U.S. Department of Transportation
Federal Highway Administration

Refer to: HNG-14

Thank you for your March 17 letter to Lawrence A. Staron requesting Federal Highway Administration's (FHWA) acceptance of your company's aluminum extrusion breakaway bases. Your letter was accompanied by the test report dated March 12, 1993, film and video documentation, and confidential information regarding material specifications and additional tests performed. Additional information and drawings were submitted with your letter of April 16. The pendulum testing was conducted to assess the breakaway performance of the base with various Hapco aluminum poles. The tests were witnessed by Mr. Nicholas Artimovich of this office. Requirements for breakaway supports are found in the 1985 American Association of State Highway and Transportation Officials (AASHTO) "Standard Specifications for Structural Supports for Highway Signs, Luminaires and Traffic Signals." These specifications have been adopted, with minor modifications, by the FHWA.

TITLE 8" EXTRUSION BASE	
CUSTOMER	
SCALE	DATE 04/16/93
BY PL	DWG. NO. A73089
CHK'D

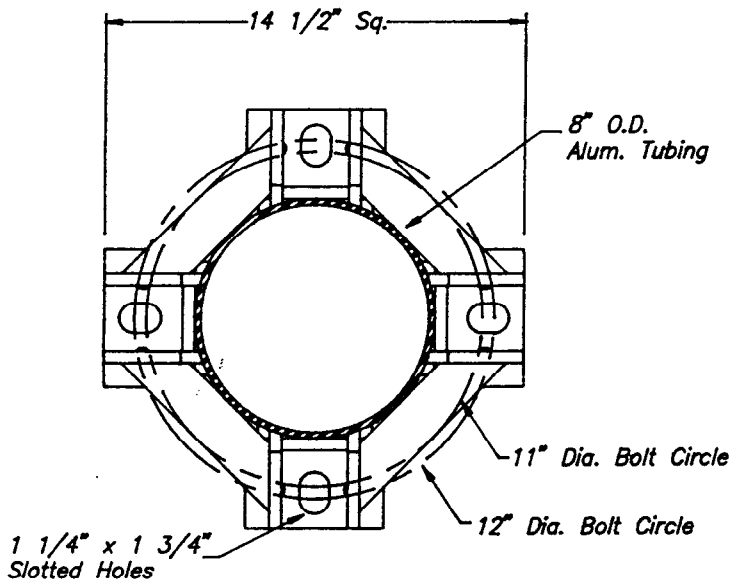
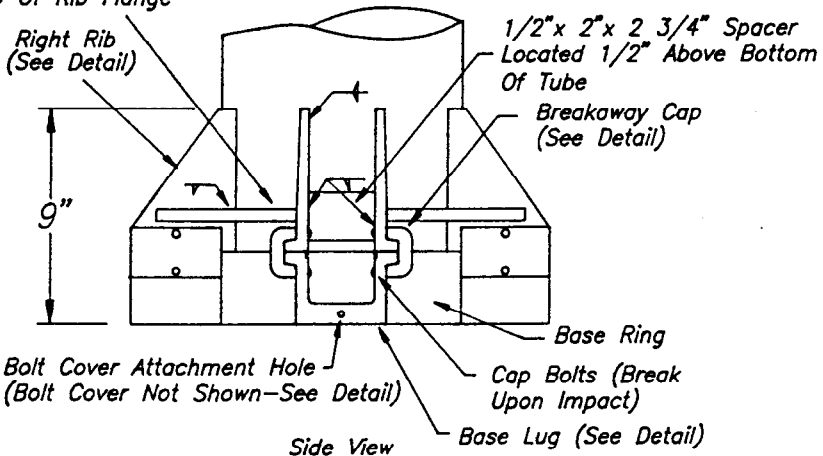
The breakaway bases, which are shown in the enclosed drawings, are essentially slip bases. The bending capacity of the bases comes from the breakaway caps that hold the flanges on the ribs attached to the poles to the mating flanges on the base lugs. Breakaway comes from an impact force breaking the bolts that hold the breakaway caps in place. A friction-reducing tape on the clamp faces of the breakaway caps aids in activation of the breakaway mechanism.

The results of the tests summarized above meet the change in velocity and stub height requirements adopted by AASHTO and FHWA. Therefore, the tested extruded aluminum breakaway bases A73089 and A73088, described above, for 203-mm (8-inch) and 254-mm (10-inch) butt diameter aluminum luminaire supports, respectively, with wall thicknesses from 4.77 mm to 6.35 mm are acceptable for use on Federal-aid highway projects, within the range of conditions tested, if proposed by a State. This acceptance also applies to intermediate base sizes, provided appropriate stiffening is included at the base ends of the pole shafts.
